Re: ACP-323635-25 Strategic Infrastructure Development - Proposed development of 9 no. wind turbines, grid connection and all associated site works. Located in the townlands of Garrane, Ballynagoul, Creggane and Charleville, Co. Limerick.

**DIRECTOR GENERAL'S REPORT IN ACCORDANCE WITH THE
REQUIREMENTS OF SECTION 37E (4) OF THE PLANNING AND
DEVELOPMENT ACT 2000 (AS AMENDED) IN RELATION TO GARRANE
WINDFARM**

ACP REFERENCE: PAX91.323635

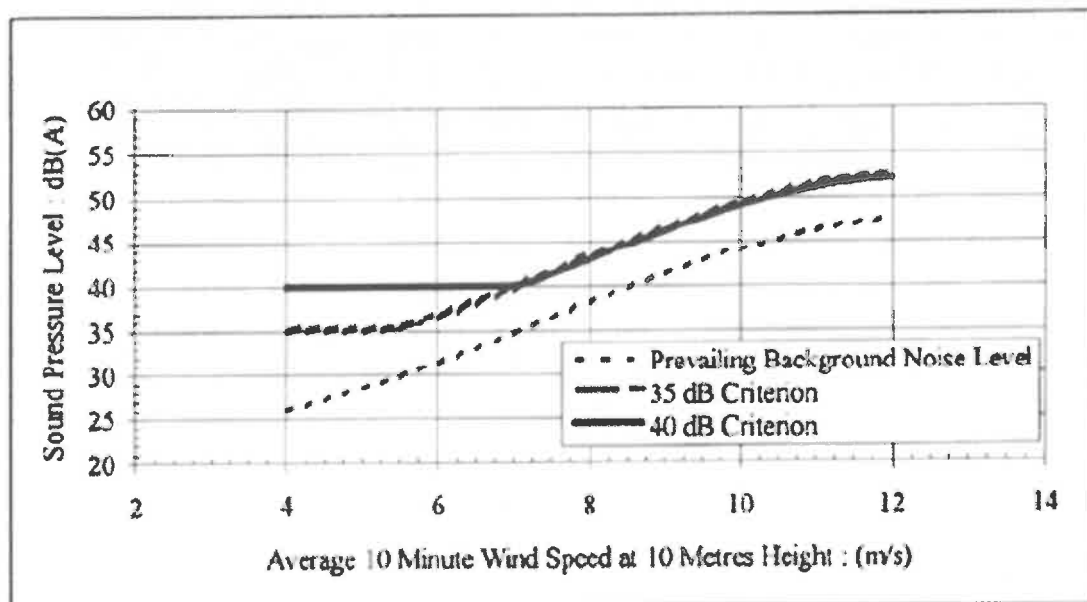
There is a discrepancy between the approach in the ACP noise condition and by LCCC for deriving wind turbine noise limits based on the WEDG (2006).

The WEDG (2006) makes a broad preliminary statement that a lower fixed limit of 45 dB(A) or a maximum increase of 5dB(A) above background noise at nearby noise sensitive locations is considered appropriate to provide protection to wind energy development neighbours. It then goes on to detail the methodology and limits in detail by taking those from the UK Guidance (ETSU-R-97) which is referenced in Appendix 6 of the WEDG.

The implication of a *low noise environment* is that for the wind speeds that the background noise is less than 30 dB(A) L90 the absolute noise limit should be between 35 and 40 dB(A) L90 but otherwise the noise limit should not be 5 dB above background noise (Example presented below from Figure 10 of ETSU-R-97).

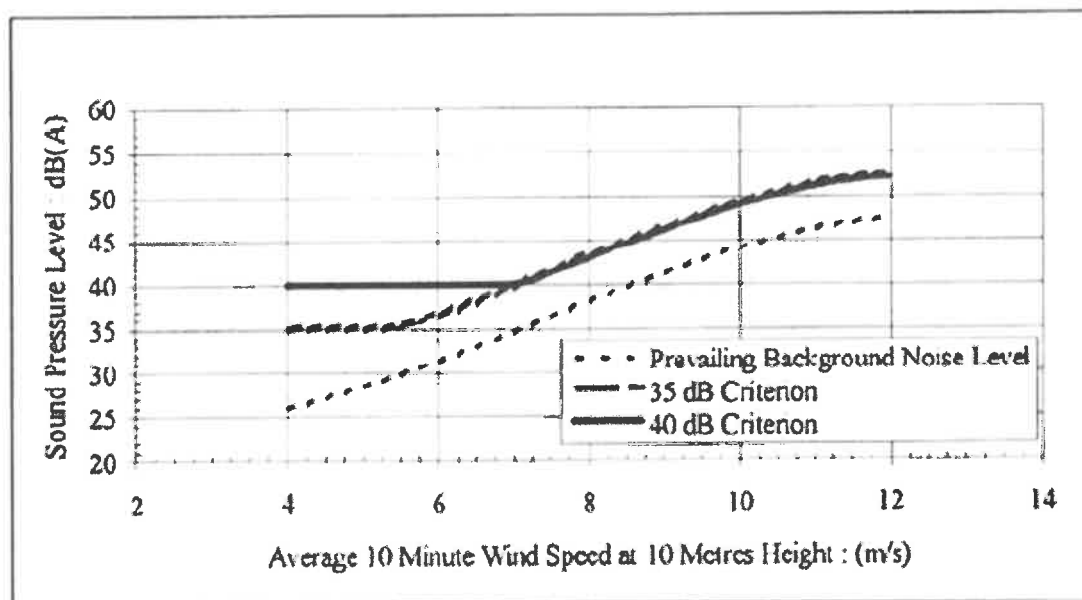
There is a discrepancy between the approach in the ACP noise condition and by LCCC for deriving wind turbine noise limits based on the WEDG (2006).

The WEDG (2006) makes a broad preliminary statement that a lower fixed limit of 45 dB(A) or a maximum increase of 5dB(A) above background noise at nearby noise sensitive locations is considered appropriate to provide protection to wind energy development neighbours. It then goes on to detail the methodology and limits in detail by taking those from the UK Guidance (ETSU-R-97) which is referenced in Appendix 6 of the WEDG.

The implication of a *low noise environment* is that for the wind speeds that the background noise is less than 30 dB(A) L90 the absolute noise limit should be between 35 and 40 dB(A) L90 but otherwise the noise limit should not be 5 dB above background noise (Example presented below from Figure 10 of ETSU-R-97).

The red image is an EU Copernicus satellite image of the flooding as of 13 November.

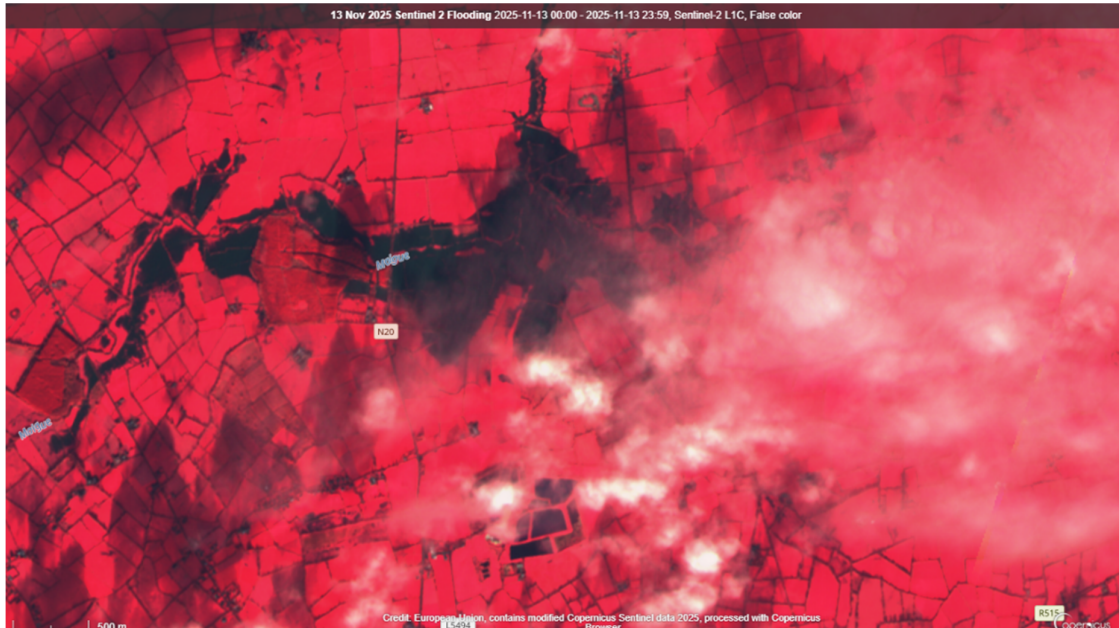
I attach pictures, a satellite image and a video of the current flooding on the N20 and adjacent windfarm site, to illustrate the reality of flooding at present, before any impermeable surfaces are added. Any further reduction of floodplain storage in this Flood Zone A could have grave long-term consequences for regional Cork-Limerick connectivity as well local houses and farmland.

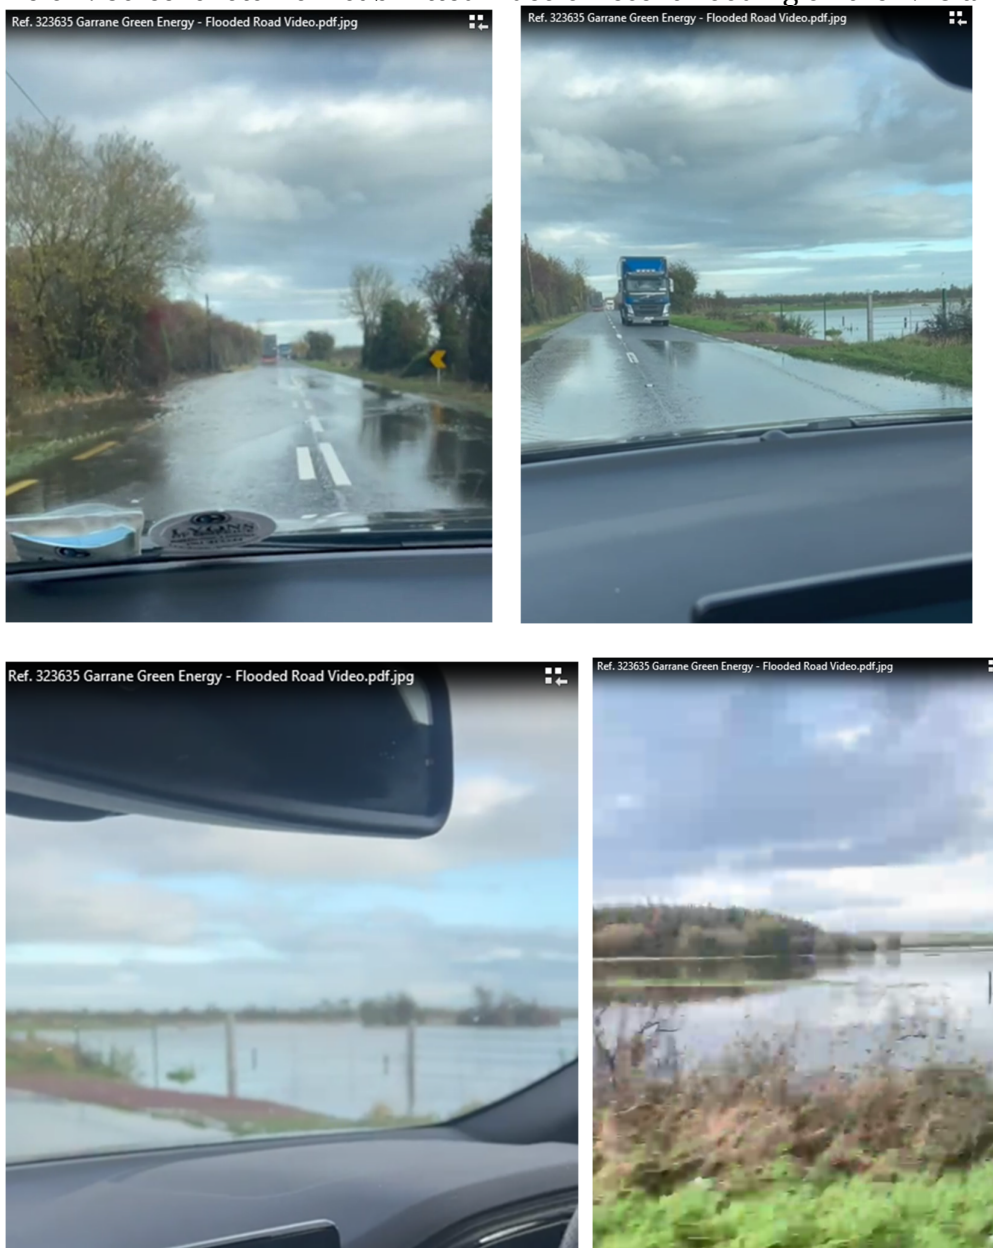
I would also like to point out that the current map on the Limerick Development Plan showing this area as favourable is not based on any science and does not show Towns, Villages or settlements. The map is also under review.

Figure 5 SAR Seasonal Flood Maps, 2015-2021. Geological Survey of Ireland, Groundwater Flooding Data Viewer. <https://dcenr.maps.orkais.com/apps/webappviewer/index.html?id=848f83c85799436b808652f9c735b1cc>

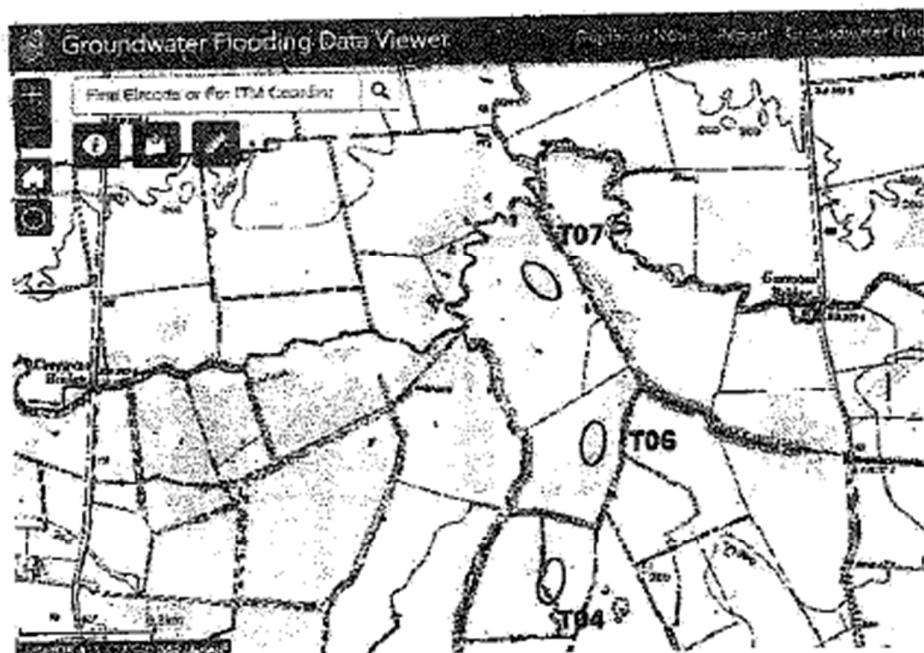
- 1) 2020/21 winter flooding in north-west Ballynagoul, south-east Garrane and north-east Creggane, covering windfarm roadway, Turbine 6, Turbine 7 and part of Turbine 4 (Source: GSI Groundwater Flooding Data Viewer, SAR Seasonal Flood Maps; Figure 5 below).

- 2) 2018/19 winter flooding in north-west Ballynagoul, south-east Garrane and north-east Creggane, covering windfarm roadway and Turbine 6 (Source: GSI Groundwater Flooding Data Viewer, SAR Seasonal Flood Maps; Figure 5 below)

- 3) 2017/18 winter flooding in north-west Ballynagoul, south-east Garrane and north-east Creggane, covering windfarm roadway, Turbine 6 and part of Turbine 4 (Source: GSI Groundwater Flooding Data Viewer, SAR Seasonal Flood Maps; Figure 5 below).

Figure 5 SAR Seasonal Flood Maps, 2015-2021. Geological Survey of Ireland, Groundwater Flooding Data Viewer. <https://dcenr.maps.arcgis.com/apps/webappviewer/index.html?id=848f83c85799436b808652f9c735b1cc>

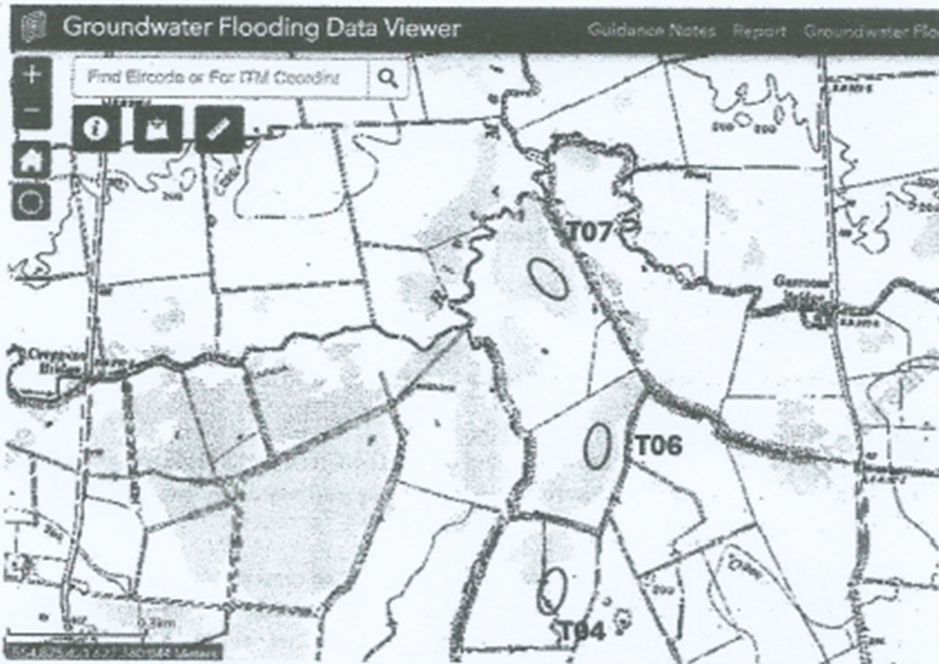
- 1) 2020/21 winter flooding in north-west Ballynagoul, south-east Garrane and north-east Creggane, covering windfarm roadway, Turbine 6, Turbine 7 and part of Turbine 4 (Source: GSI Groundwater Flooding Data Viewer, SAR Seasonal Flood Maps; Figure 5 below).

- 2) 2018/19 winter flooding in north-west Ballynagoul, south-east Garrane and north-east Creggane, covering windfarm roadway and Turbine 6 (Source: GSI Groundwater Flooding Data Viewer, SAR Seasonal Flood Maps; Figure 5 below)

- 3) 2017/18 winter flooding in north-west Ballynagoul, south-east Garrane and north-east Creggane, covering windfarm roadway, Turbine 6 and part of Turbine 4 (Source: GSI Groundwater Flooding Data Viewer, SAR Seasonal Flood Maps; Figure 5 below).

Figure 1 Garrane Green Energy's proposed development in **CFRAM High Probability Current Day Scenario Flood Extent**, i.e. "1-in-a-10 chance of occurring or being exceeded in any given year." (OPW. <https://www.floodinfo.ie/map/floodmaps/>).

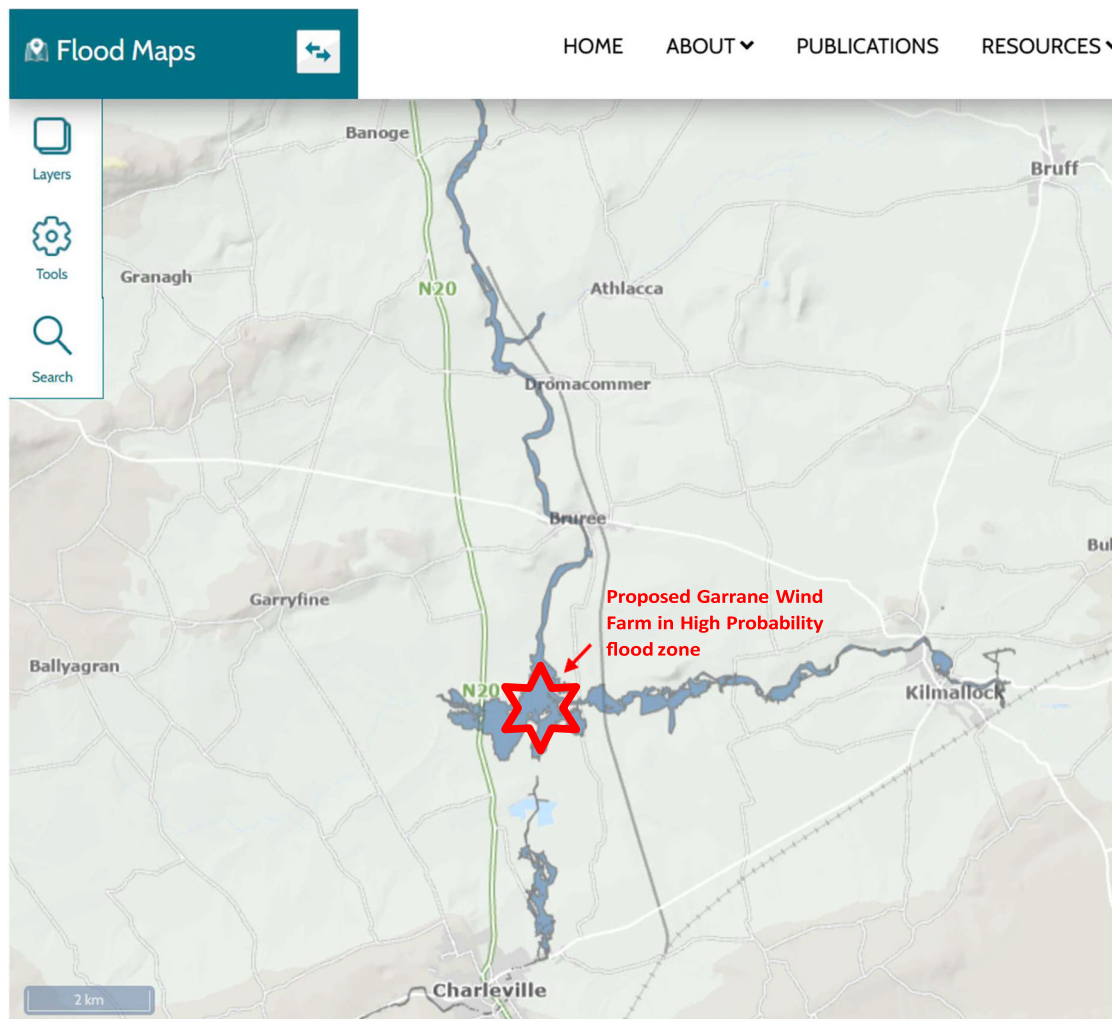
- p.38 - "The River Maigue channel floodplain is constrained downstream of the Site by adjacent local topography. This is observed as the flood zones in the CFRAM flood maps do not extend significantly east or west of the river channel alignment. This natural geometry limits the potential for local downstream water levels effects. Also, as outlined above the modelling demonstrates there is no significant change in modelled water levels downstream of the site after including the proposed wind farm. As there are no effects downstream (within the modelled area) there can be no further transfer of effects downstream."

Indeed, there is a chokepoint downstream on the Maigue at Bruree village. But what they neglect to mention is that this constraining of the river *downstream* increases the chances of *upstream* flooding. Upstream flooding has always been the main risk, and this is the very aspect of flooding which the FRA does not address. Hydro-G presents the application area in the context of CFRAM mapping for flooding (actual) as Figure 1 below. It will be obvious from this that in-situ and upstream flooding is the main issue here.

The Flood Risk Assessment has very little to say about potential increases to flood risk on the N20, a piece of critical national infrastructure forming the western boundary of the site (and located in the same Flood Zone A as the proposed windfarm). The risk to the N20 is already significant. The OPW's PFRA report in 2012 recorded three past floods at Creggane Bridge on the N20 and puts it in Historic Hazard Category 2 (out of 4), meaning 1-9 properties have been flooded.¹ Furthermore, section 5.5.3 below presents a long list of additional flood events in the project site in recent decades, several of which have affected the N20. This evidence does not feature in the 'Site Specific' Flood Risk Assessment.

Figure 2 Detail from second edition 6 inch Ordnance Survey map, covering area where Turbines 7, 8 and 9 will be located, east of Creggane Bridge on the N20. Author's annotation and highlighted "Liable to Floo .."

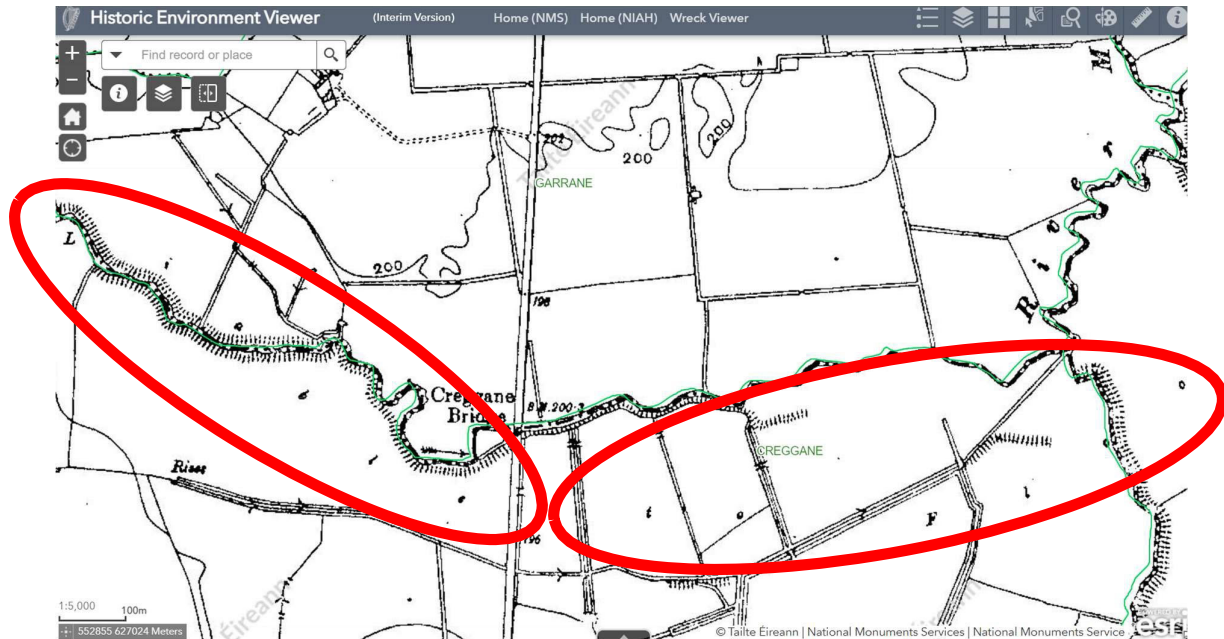
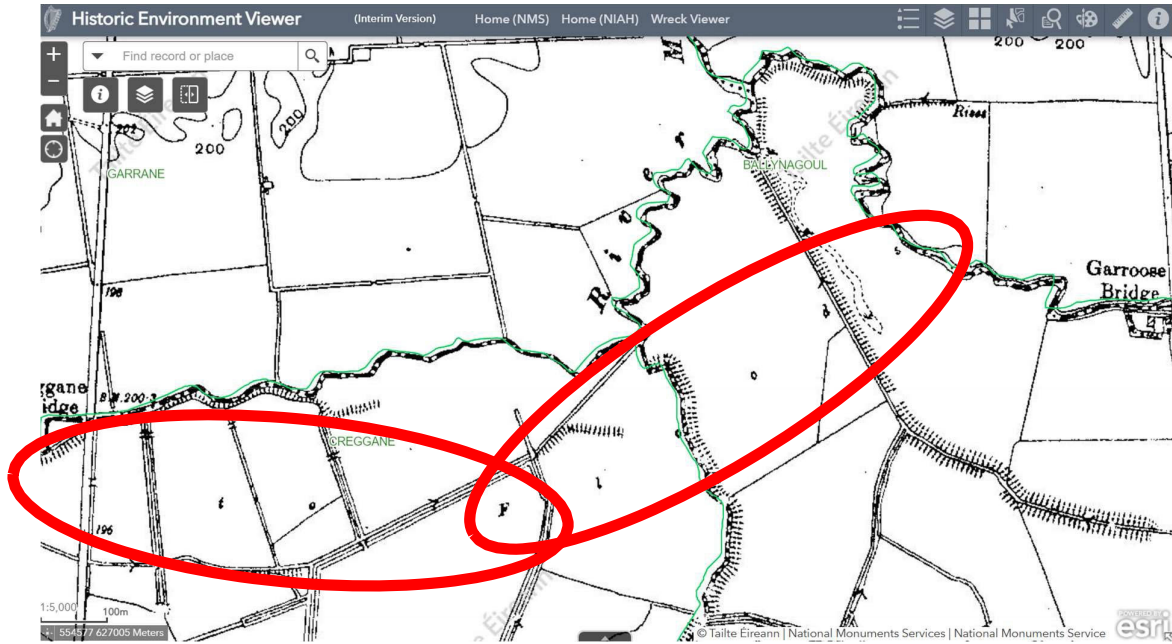
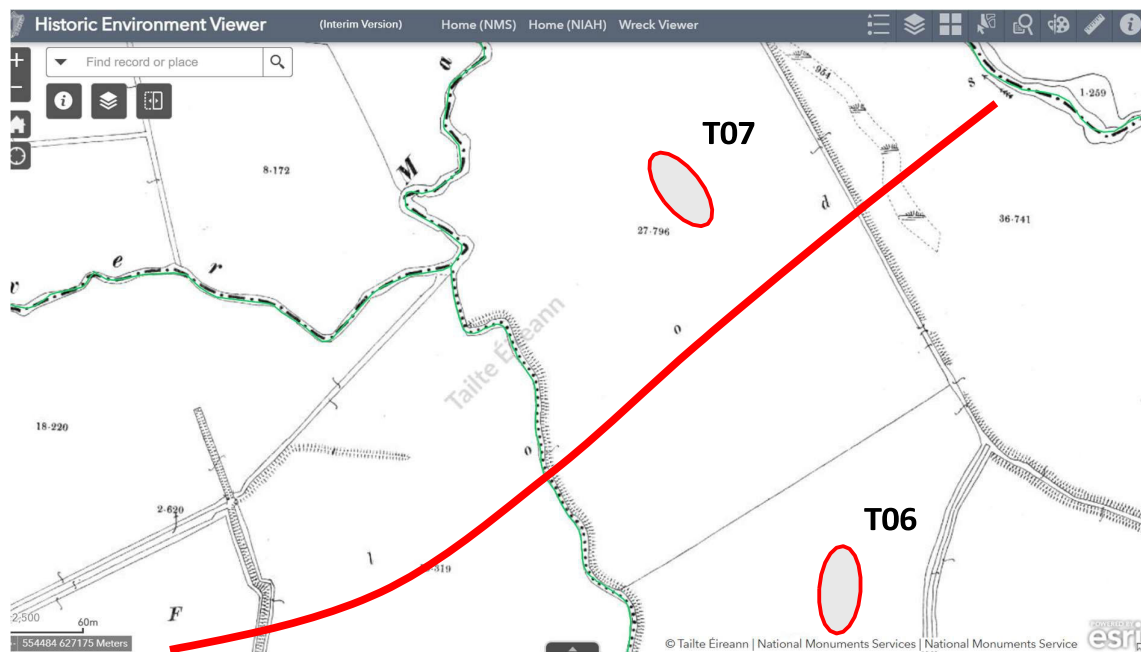
P.19 of the EIAR's Flood Risk Assessment (Appendix 10.1) says that the historic maps do not contain the text, "prone to flooding" and, based on this, it makes the **claim that "historic mapping does not record flooding as an issue"**. The conclusion of the Flood Risk Assessment doubles down on this claim, saying that, "No reference to historical flooding were [sic] identified on historic OS maps". This is inaccurate. The maps, in fact, offer strong evidence for historical flooding both inside and outside the proposed windfarm site. Both the second edition 6 inch OS map and the first edition 25 inch OS map clearly state, "Liable to Floods". On the maps, this term is stretched across a large area of land in the north of Creggane and the north west of Ballynagoul, within the proposed development area (Indeed, the term is also shown further east in Ballynagoul, along the same river). Screenshots of these maps are shown below. "Liable to Floods" is the standard terminology on historic OS maps. To claim that they don't say "prone to flooding" is to misrepresent these maps: historic OS maps for Ireland never use that phrase. "**Liable to floods**" is the standard term.⁵

An Coimisiún needs to consider why the authors of the Flood Risk Assessment would omit the fact that historic maps mark the area as, "Liable to Floods".

Figure 5 SAR Seasonal Flood Maps, 2015-2021. Geological Survey of Ireland, Groundwater Flooding Data Viewer. <https://dcenr.maps.arcgis.com/apps/webappviewer/index.html?id=848f83c85799436b808652f9c735b1cc>

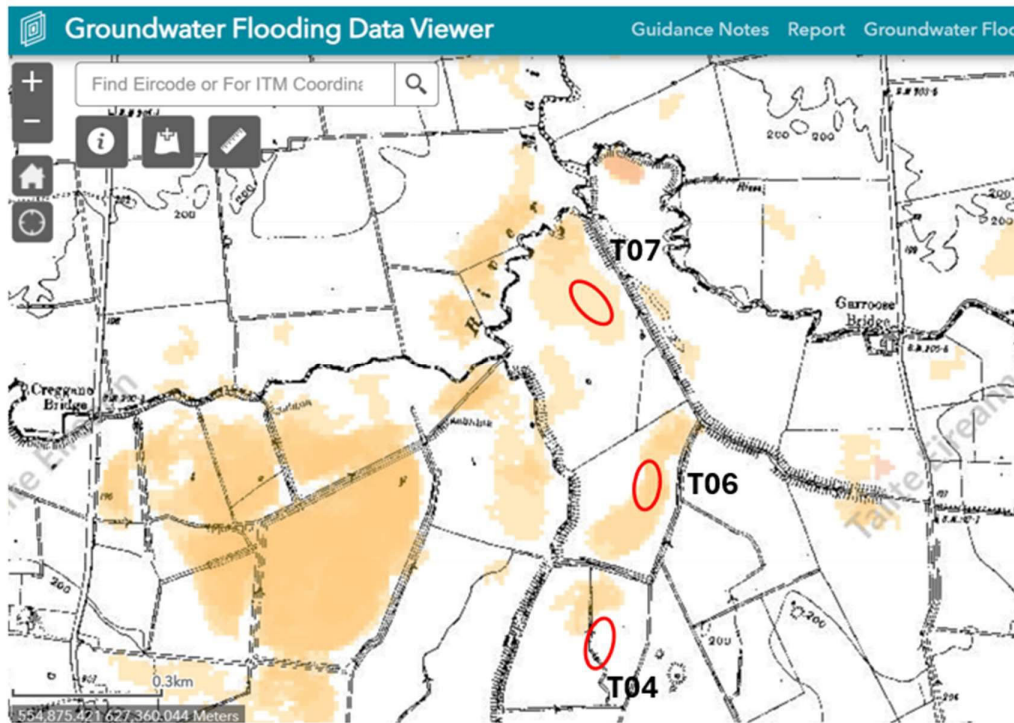
- 1) **2020/21** winter flooding in north-west Ballynagoul, south-east Garrane and north-east Creggane, covering windfarm roadway, Turbine 6, Turbine 7 and part of Turbine 4 (Source: GSI Groundwater Flooding Data Viewer, SAR Seasonal Flood Maps; **Figure 5** below).

- 2) **2018/19** winter flooding in north-west Ballynagoul, south-east Garrane and north-east Creggane, covering windfarm roadway and Turbine 6 (Source: GSI Groundwater Flooding Data Viewer, SAR Seasonal Flood Maps; **Figure 5** below)

- 3) **2017/18** winter flooding in north-west Ballynagoul, south-east Garrane and north-east Creggane, covering windfarm roadway, Turbine 6 and part of Turbine 4 (Source: GSI Groundwater Flooding Data Viewer, SAR Seasonal Flood Maps; **Figure 5** below).
